UNITED STATES  
NUCLEAR REGULATORY COMMISSION

September 15, 1994

APPLICANT: Tennessee Valley Authority (TVA)  
FACILITY: Watts Bar Nuclear Plant, Units 1 and 2  
SUBJECT: MEETING SUMMARY - AUGUST 30, 1994 MEETING WITH THE TENNESSEE VALLEY AUTHORITY REGARDING PROPOSED USE OF THERMO-LAG FIRE RETARDANT MATERIAL (TAC M63648)  
REFERENCE: Meeting notice by P. S. Tam, August 10, 1994

**Figure A1 Schematic for calculation of conduit heat losses**

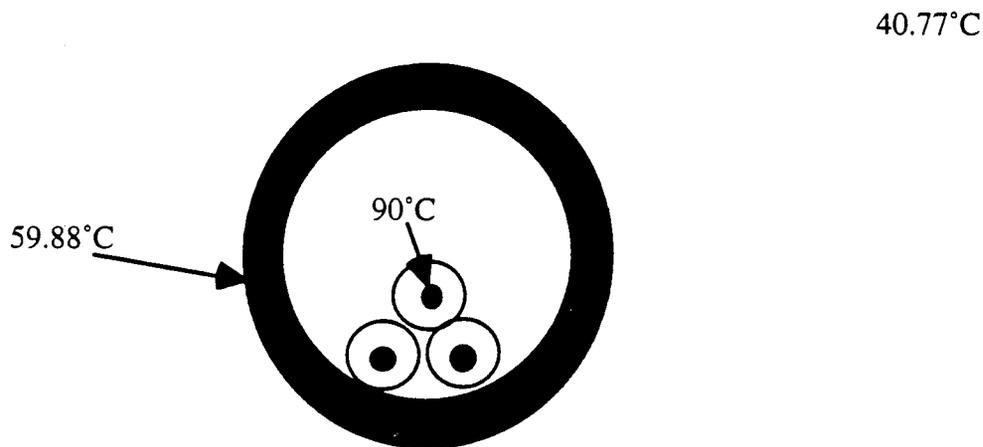
The TVA report<sup>22</sup> includes information on the temperature of the outside of the conduit for the unprotected case. For a 1" conduit, the outer conduit temperature was 59.88°C when the conductor temperature was 90°C and the ambient temperature was 40.77°C. (Figure A1).

We can calculate an effective thermal resistance (per unit length) from the conductor to the outside of the conduit by equating the heat flow from the conductor to the outside of the conduit to the heat flow from the conduit to the surrounding room.

$$\begin{aligned} q_{baseline} &= \frac{T_i - T_o}{R_{eff}} \\ &= 2\pi r_o h(T_o - T_\infty) + 2\pi r_o \epsilon \sigma (T_o^4 - T_\infty^4) \\ &\approx 13.6 \text{ W/m} \end{aligned} \quad (A7)$$

Here we have assumed that  $\epsilon = 0.22$ , a typical value for steel.  $T_i$  is the temperature of the conductor (90°C),  $T_o$  is the temperature of the outside of the conduit (59.88°C), and  $T_\infty$  is the temperature of the surrounding enclosure (40.77°C). Here we have assumed that the surrounding air temperature used to calculate conduction is equal to the enclosure wall temperature used to calculate radiation.
